RX470 rework SOP

Step 1、Replace MLCC

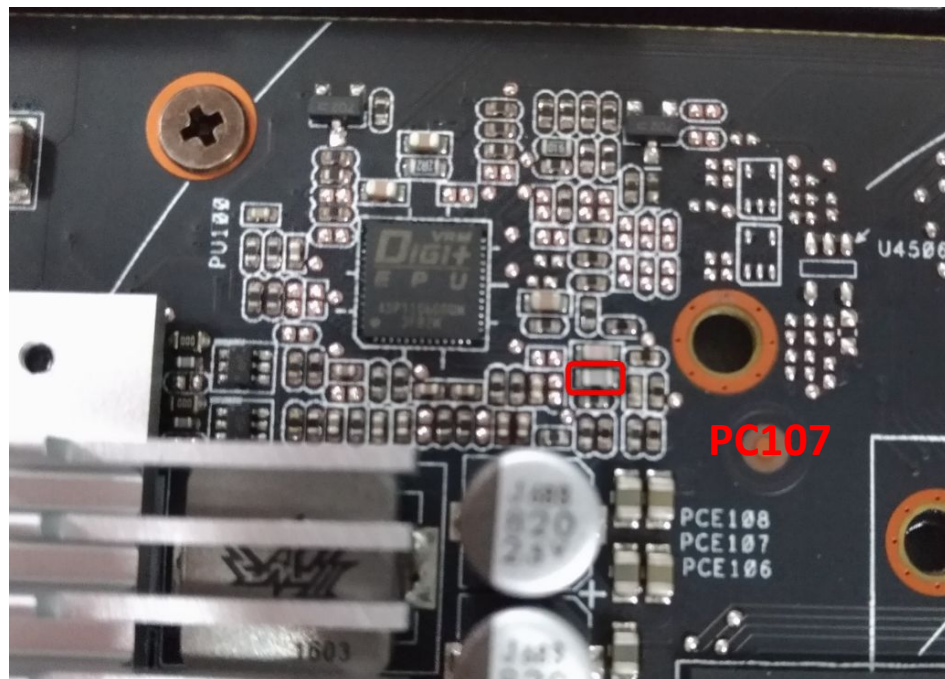
Replace the location MLCC of PC107
in red circle with 150 pf
(PN:11G233015104030)

Step2、Remove MLCC between GND and DGND

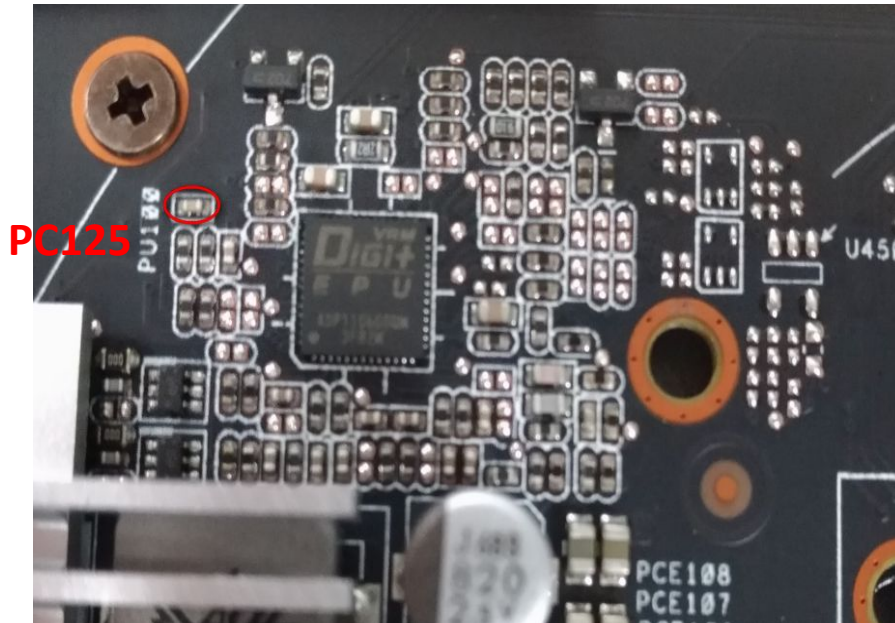
Remove the capacitance of location PC125 in the red circle of the picture
